ADDENDUM NO. 8

PROJECT: NEW FIRE STATION #27
COSA, San Antonio, TX

DATE: December 9, 2010

ROOF DECK KEY PLAN

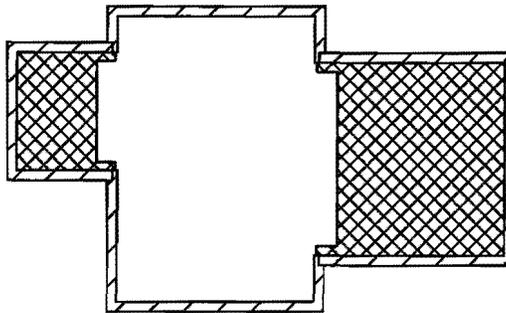
7. **Sheet S2.2 – Roof Framing Plan:**
 - A. *Revise* drawing in accordance with Item #1 on *Attachment “A”*.
8. **Sheet S2.3 – Retaining Wall Framing Plan:**
 - A. *Revise* drawing in accordance with Item #5 on *Attachment “A”*.
9. **Sheet S4.1 – Notes, Sections, and Details:**
 - A. *Revise* drawing in accordance with Item #2 and Item #3 on *Attachment “A”*.

-  - DECK IS SHOP PAINTED/WELDED NOT FLIPPED (REF. SF-16)
-  - FLIPPED DECK IS SHOP PAINTED/SCREWED (REF. SF-4)
-  - FLIPPED DECK IS GALVANIZED/SCREWED (REF. SF-5)

ITEM #1:
